ADDENDUM NO. 3
PROJECT MANUAL
CITY OF BRYAN
BRYAN, TEXAS
BRYAN-COULTER AIRFIELD APRON EXPANSION
TXDOT CSJ NO. 2617BRYAN

This Addendum to the Bid Documents is issued to modify, explain, or correct the original Technical Specifications for Bryan-Coulter Airfield Apron Expansion (TxDOT CSJ No. 2617BRYAN) and is hereby made part of the Contract Documents. Acknowledgement of receipt of this addendum is required on the signature page of the Bid Form. Failure to acknowledge all addenda could render your Bid out of form and result in a non-responsive Bid.

ALTERNATIVE BID NO. 1
CONSTRUCT, MAINTAIN, AND REMOVE HAUL ROUTE

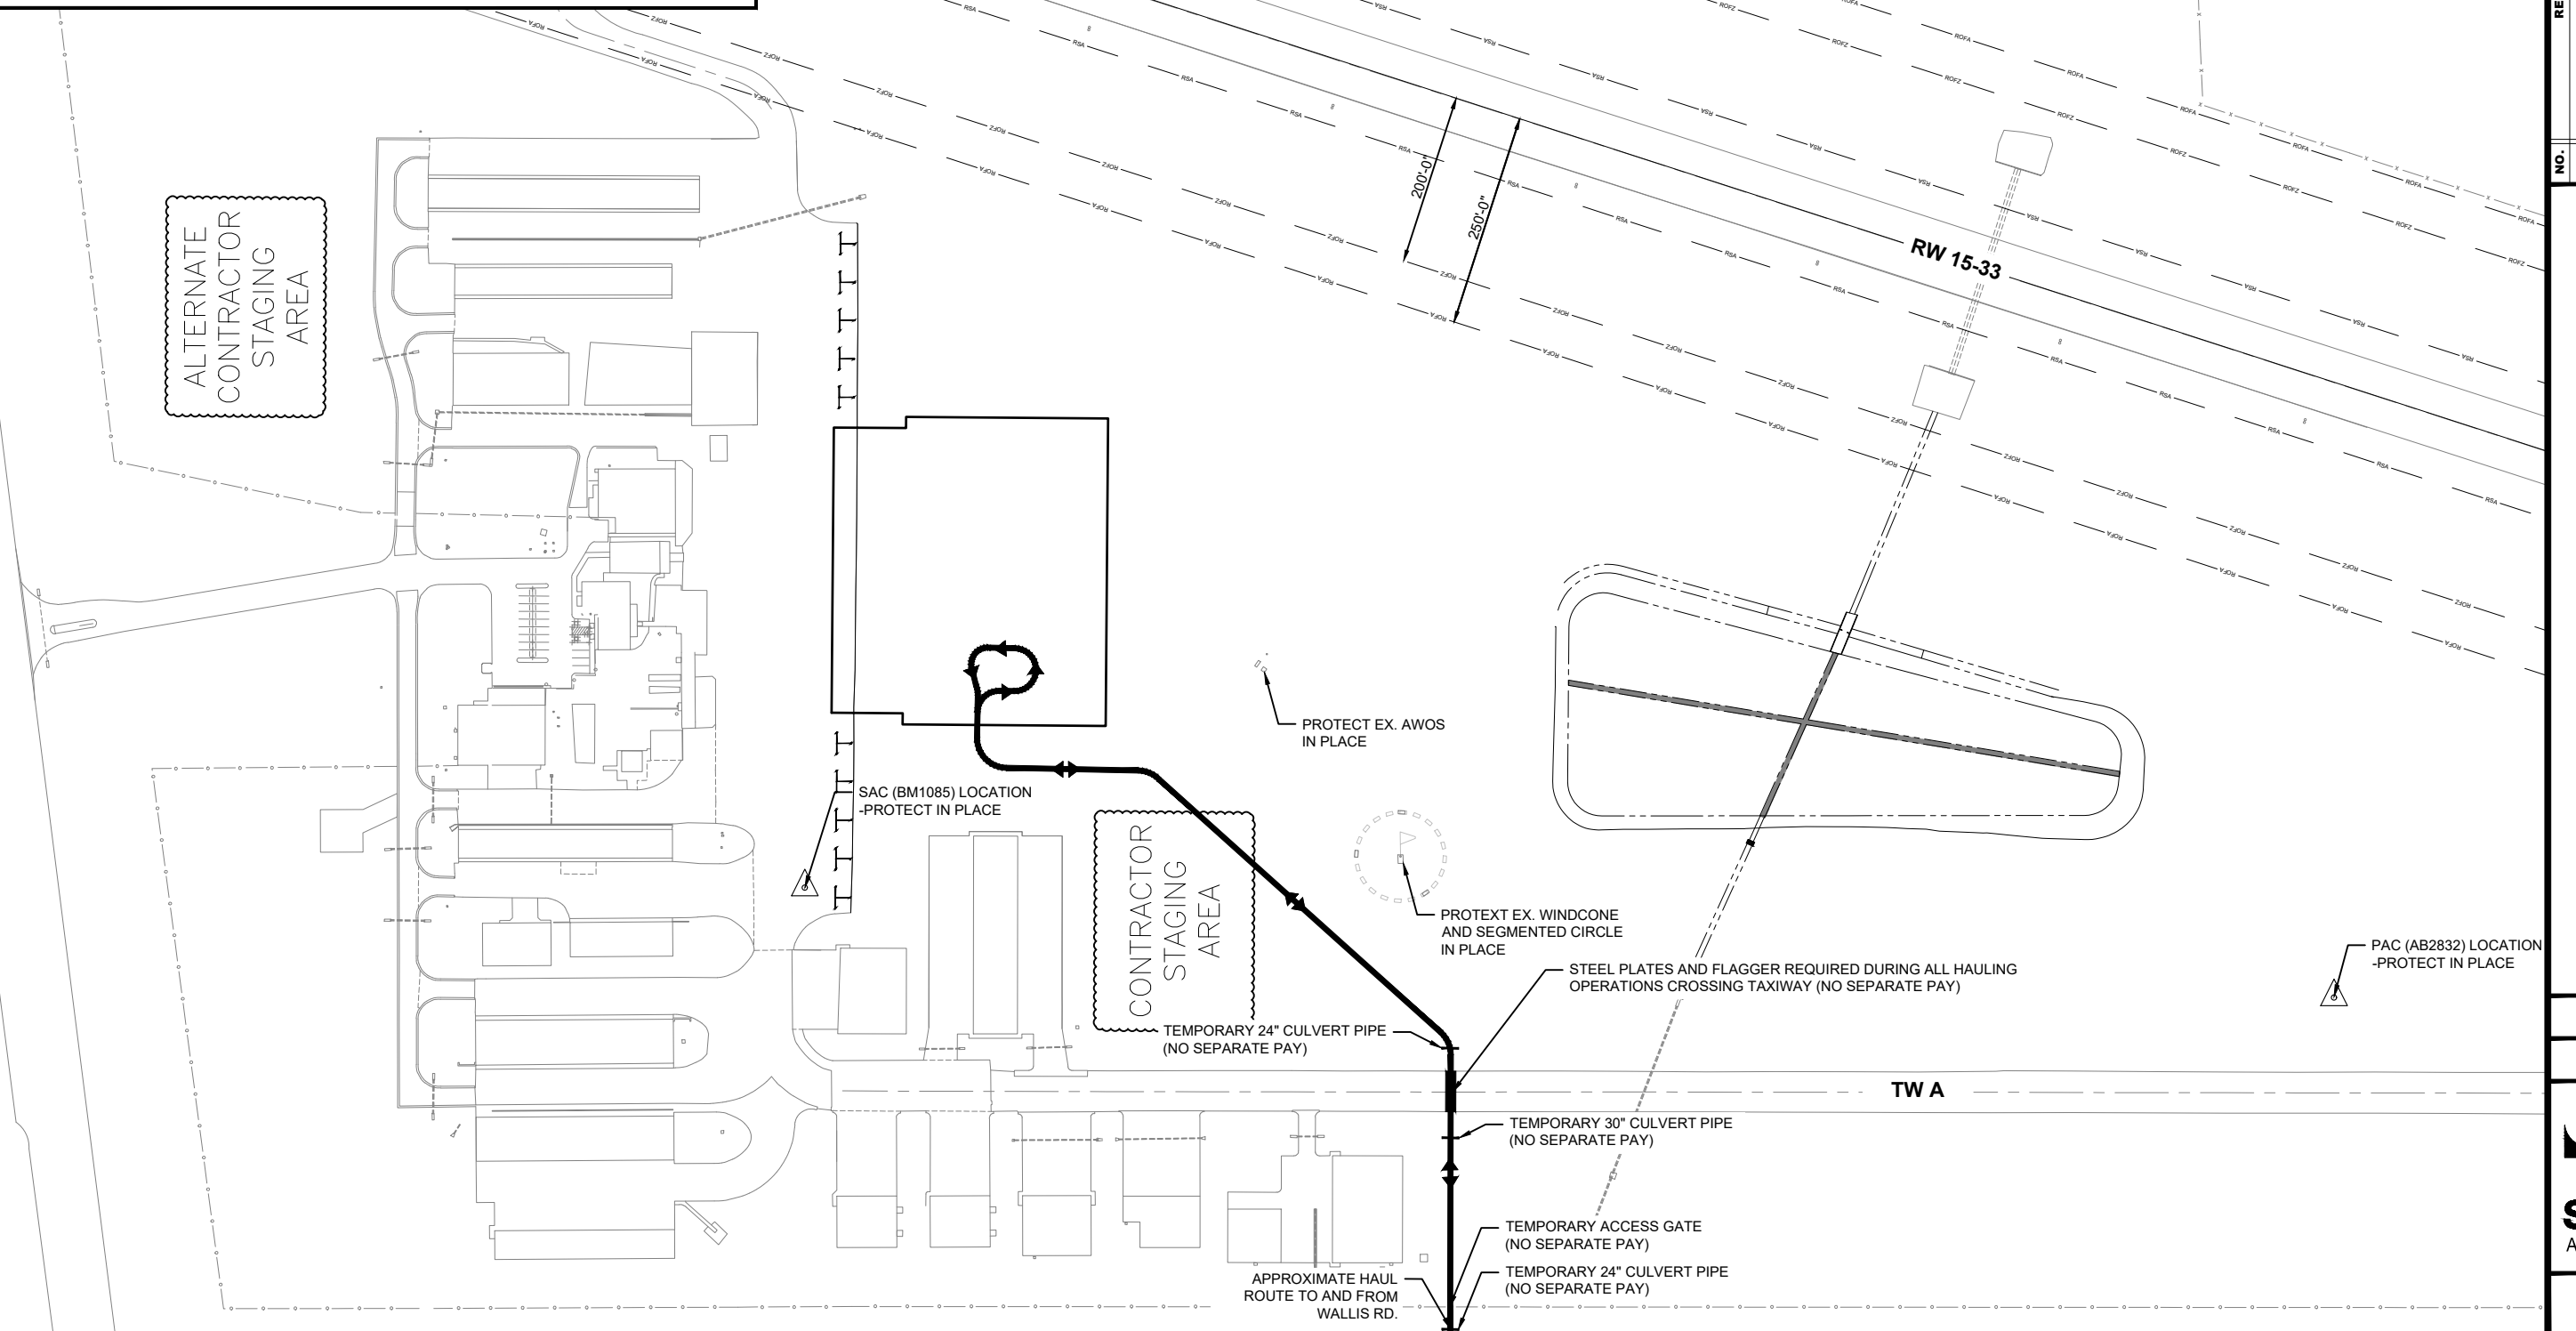
- b. A contractor asked for clarification regarding the two haul routes. Engineer stated that the Base Bid haul route includes the rehabilitation of asphalt and concrete as necessary during and after the project. Engineer stated that Alternative Bid No. 1 includes a bid item to remove the Base Bid haul route cost and add the haul route from Wallis Road. Alternative Bid No. 1's haul route includes the construction, maintenance, and removal of this route. Information about the Alternative Bid No. 1 haul route is included in Addendum No. 2.

- c. A contractor inquired if there was a detail for the steel plating associated with the Alternative Bid No. 1 haul route. Engineer stated that information is included in the Drawings and Specifications. No further details will be provided.

- j. Owner stated that the contractor shall coordinate runway closures with Owner and Engineer. Owner will need to coordinate runway closures with Airport tenants in advance, according to the General Phasing Notes on Drawing Sheet No. 12.
- k. Contractor inquired whether the temporary gate included in the Alternative Bid No. 1 haul route could remain after construction completion. Owner stated that the temporary gate could remain after construction completion. The temporary gate material shall be approved by Engineer and Owner before installation.

REPLACE Sheet No. 9A with the attached revised Sheet No. 9A.

PAVEMENT DETAILS

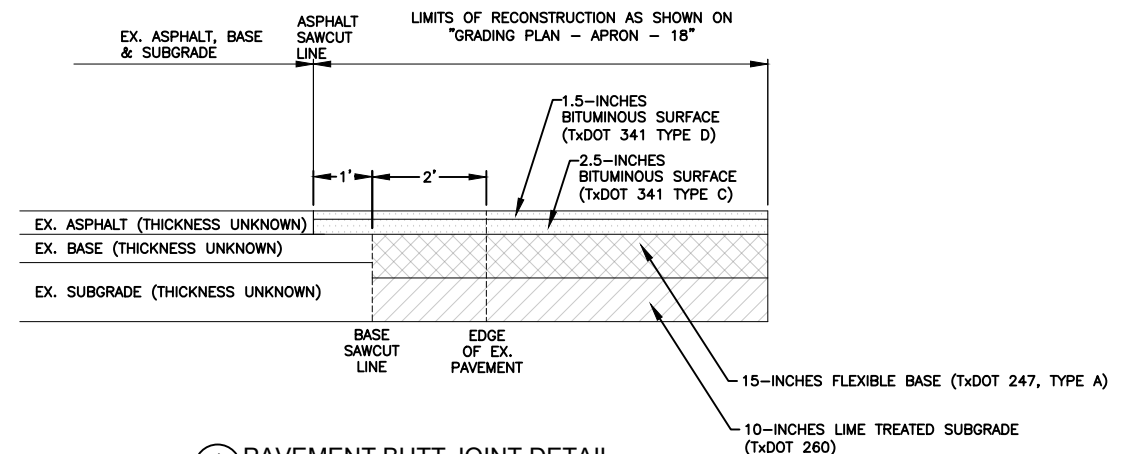
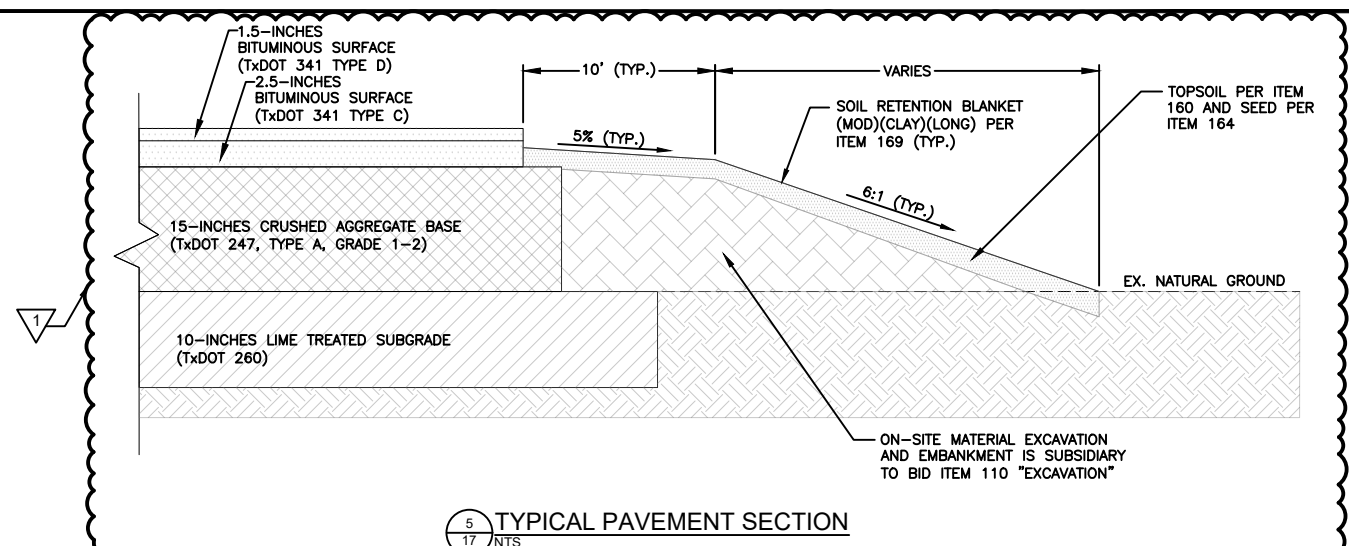
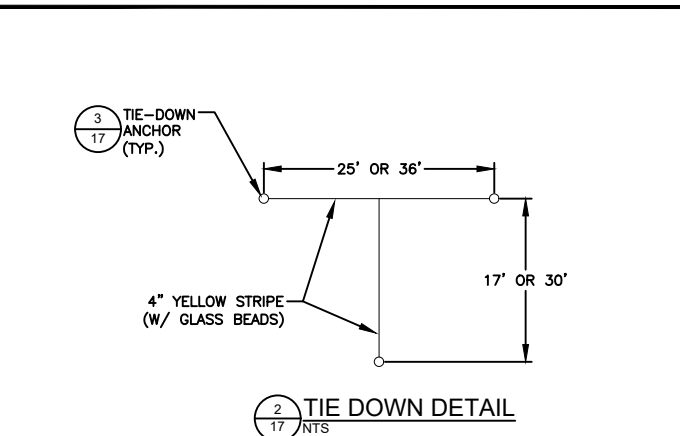
- a. Engineer noted that the following question was asked before the Nonmandatory Prebid Conference: How far beyond the base does the lime-treated subgrade extend? Engineer answered that the lime-treated subgrade extends 7 feet beyond the base and 9 feet beyond the pavement. A detail will be provided in Addendum No. 3.

REPLACE Sheet No. 17 with the attached revised Sheet No. 17.
